HUEY P. LONG DECORATIVE LIGHTING 2ND TO 5TH STREETS PROJECT
BKI PROJECT NO: 9344-8350-1
DATE: 4/6/2025

HUEY P. LONG DECORATIVE LIGHTING 2ND
TO 5TH STREETS PROJECT

BKI PROJECT NO: 9344-8350-1

ADDENDUM NO. 2
DATE ISSUED: April 6, 2025

1 TYPICAL STREET LIGHT FOUNDATION
E.301 E.301 N.T.S.

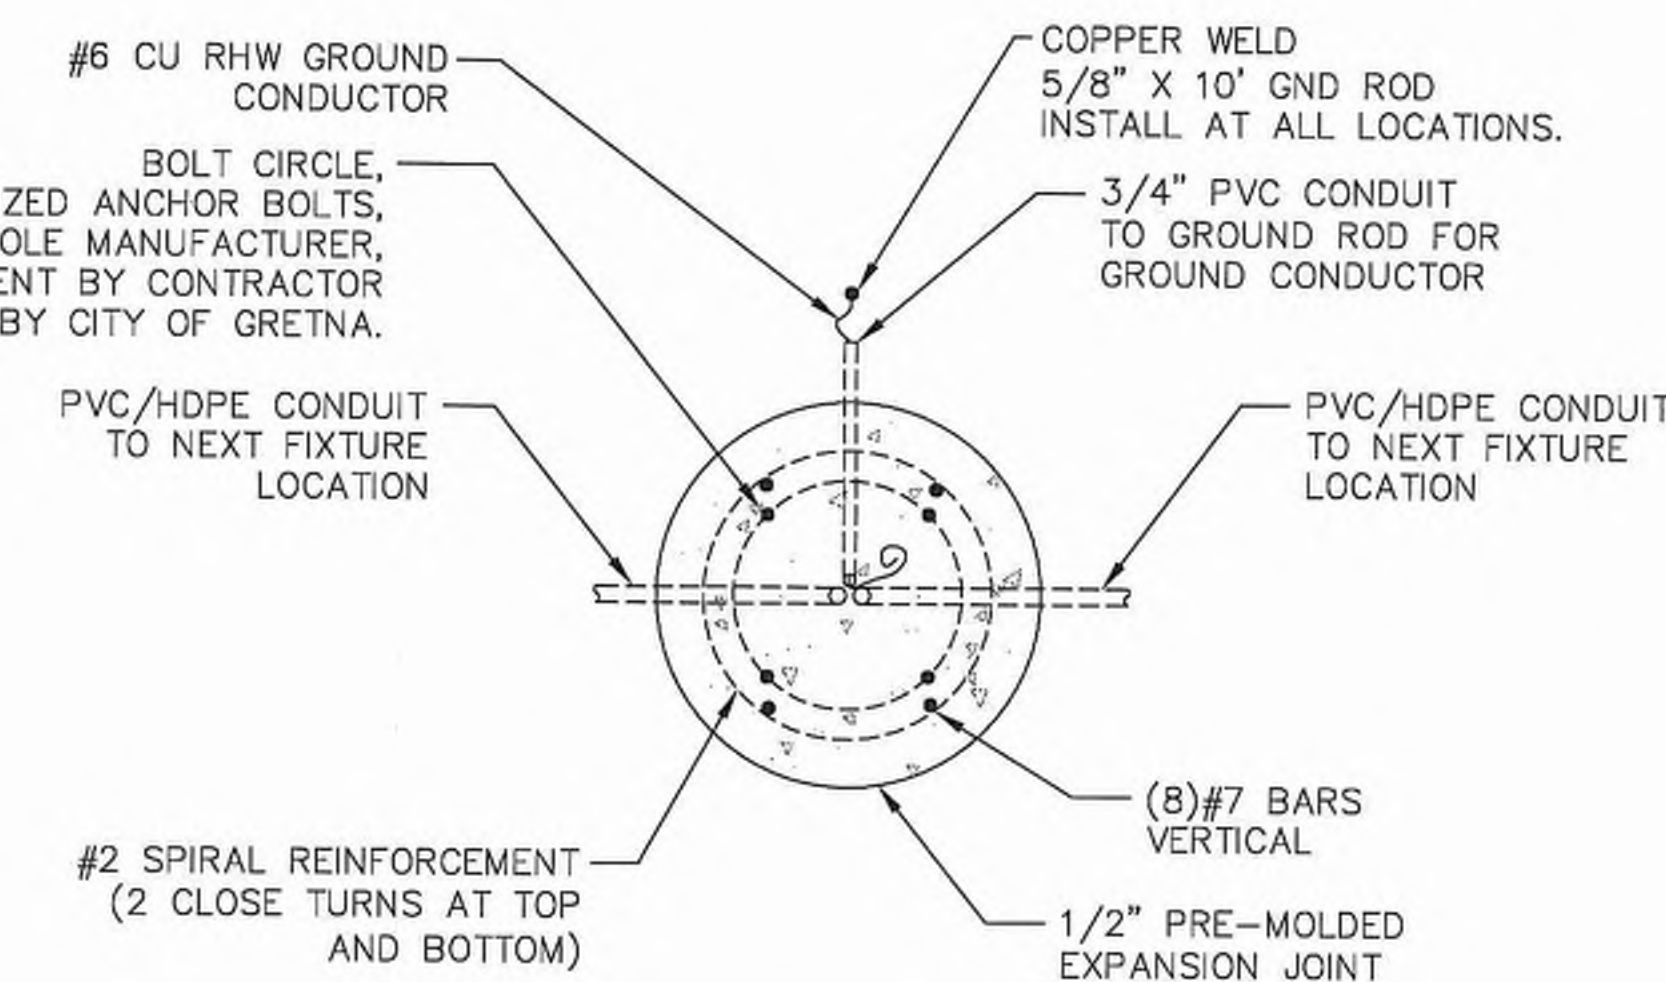
Question 2: For street light foundations that do not have in-grade hand holes adjacent, what are contractors to do with the copper conductors that will be coiled up at each pole base?

Response: Contractor to install conductors in a properly sized junction box to capture raceway and conceal conductors. Contractor to provide 24" of conductor length per conductor. Conductors shall be terminated in junction box with insulated mechanical multi-tap connectors, 6061-T6 aluminum construction, set-screw, number of ports as required, black insulated, UL Listed, ILSCO PBTS series, POLARIS series, or approved equal.
